Response to Technical Note 5 (Update)

**Brook Green
Land at Fritch Way, Rayne
January 2017**

**Response to Technical Note 05 (Update) – Brook Green
January 2017**

Type of report: Technical Note Response

client: Acorn Group Braintree	title: A120 Northern Roundabout Proposed Segregated Left Turn Lane	date: 4/11/2016	scale @ A3 1:1000
project: Brook Green	status: Planning	drawn:	Revision a
discipline: Transport Planning	project no: JTP 06414	chk'd: SAA	dwg no: DR10

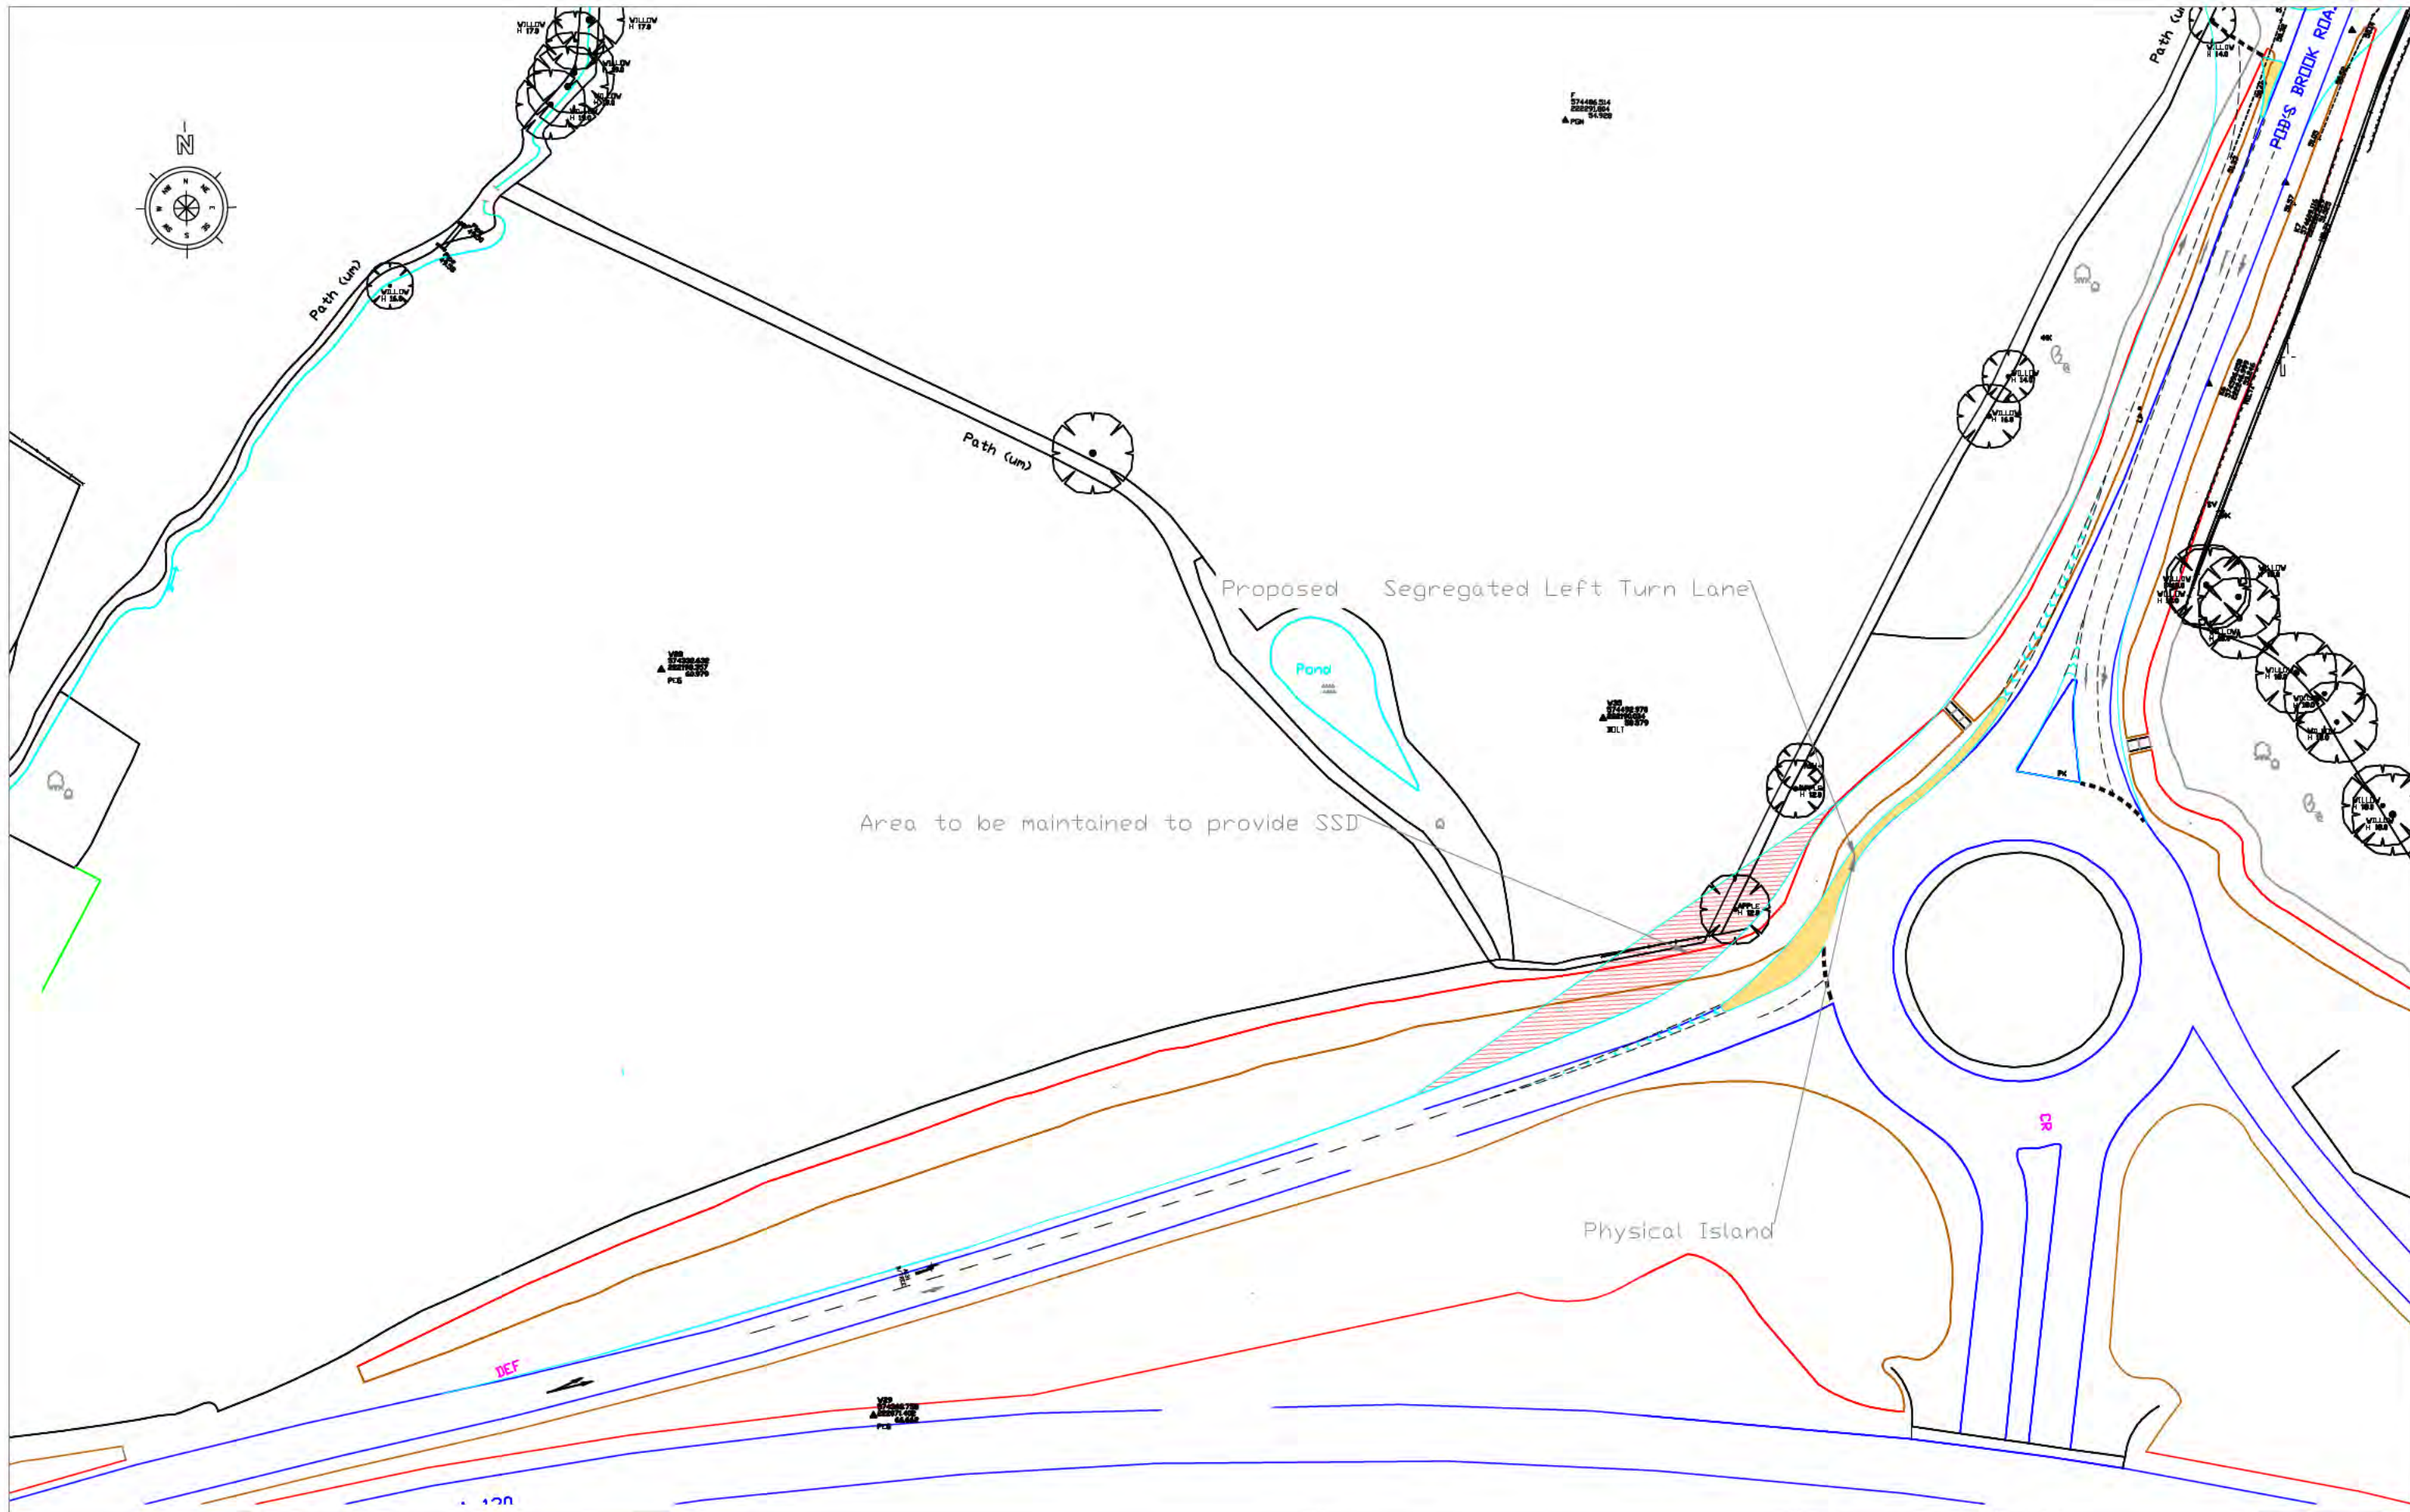
3.3 In consideration of the design audit comments the segregated left turn lane has been redesigned to comply where possible with the relevant design standards as noted from the audit.

3.4 The principle improvements to the design are as follows:

- The segregated left turn is provided at a constant width throughout the lane in accordance with the entry radius value
- The circulatory carriageway width on the roundabout is constant
- The Entry and Exit Taper lengths have been amended to comply with standard
- The lane width at the start of the entry taper has been reduced to 3.5m
- The visibility envelope along the lane has been improved to accommodate 90.0m forward visibility along the slip road approach
- The Pods Brook road exit width has been modified to comply with standard
- The entry width has been reduced to provide a DMRB compliant entry width and also
- The splitter island on the Pods Brook Road exit has been modified to provide improved exit width
- The gradient of the A120 EB slip road approach has been assessed on site and is confirmed at less than 4%

3.5 The proposed modified A120 north roundabout layout is held in **Appendix 2**.

title: Pods Brook Road Access Roundabout and carriageway widening

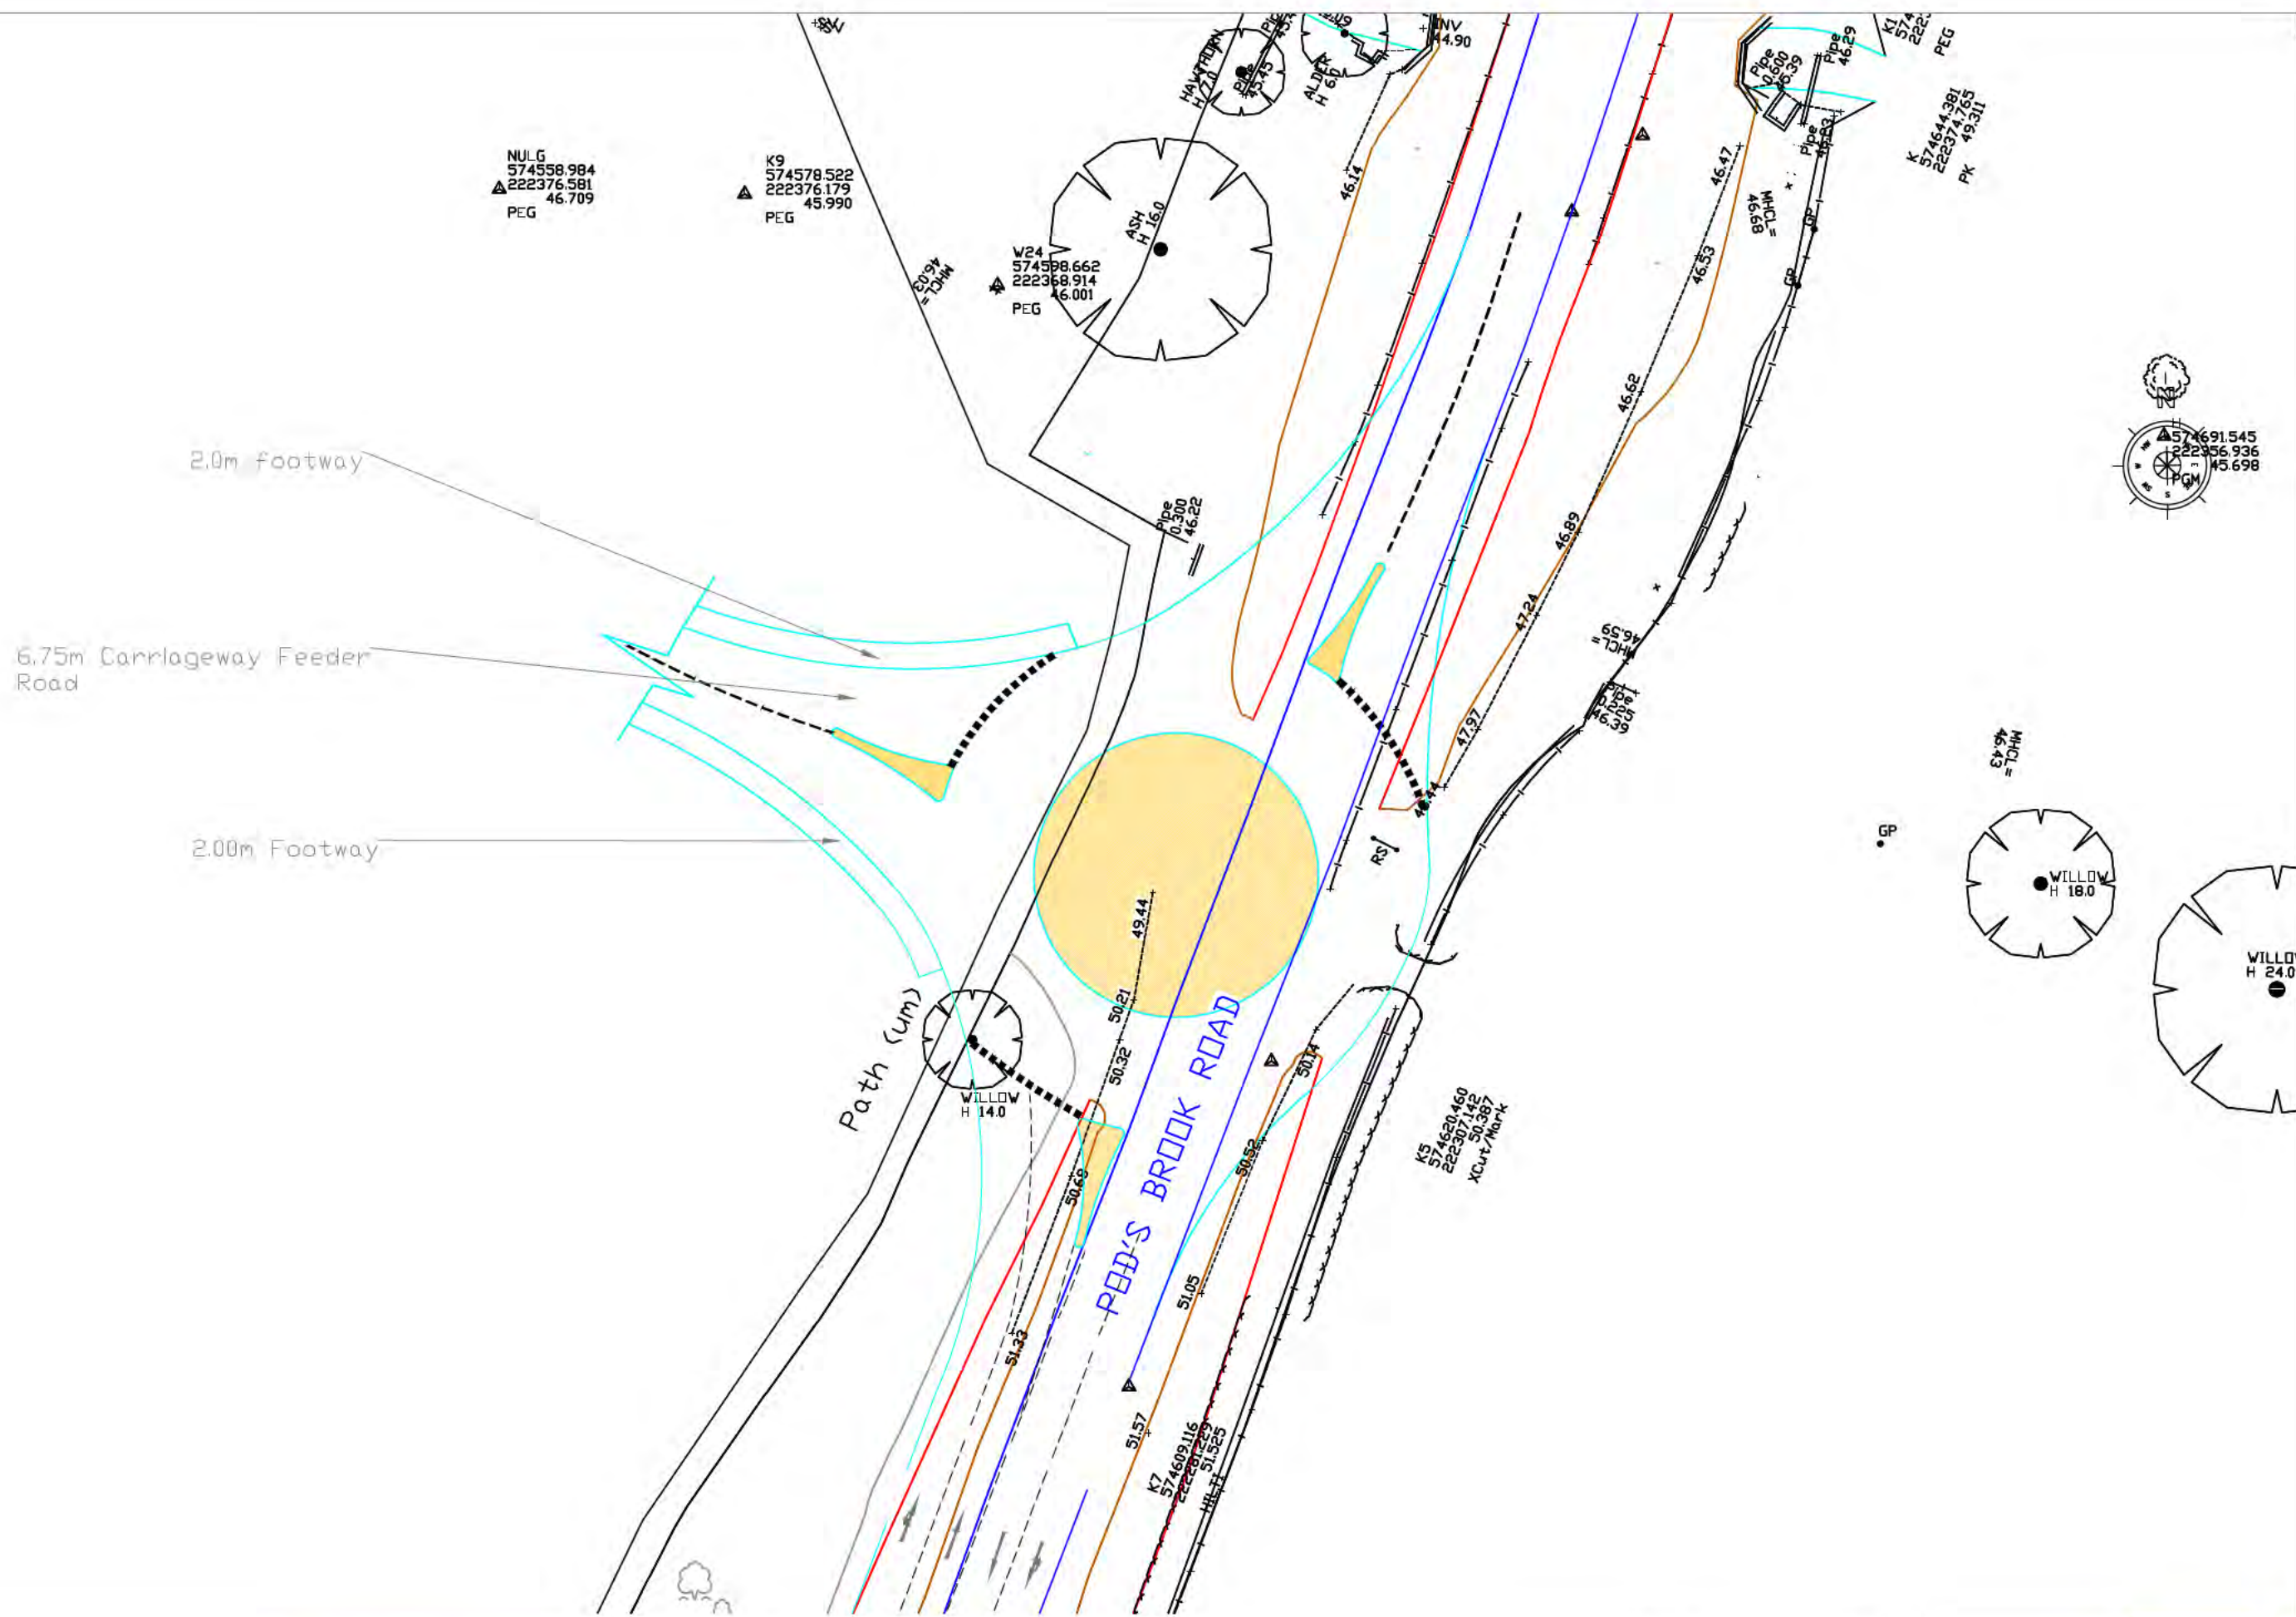
Brook Green Access Roundabout

- Total road width has been amended to provide 4 lanes at 3.50m wide

- The roundabout design has been amended to accommodate the additional northbound lane with additional entry width being provided at the Pod's Brook Road north bound entry.
- Additional exit width is provided at the Pod's Brook Road northbound exit to accommodate the two lane approach

3.6 The proposed Access Roundabout layout is held in **Appendix 3**.
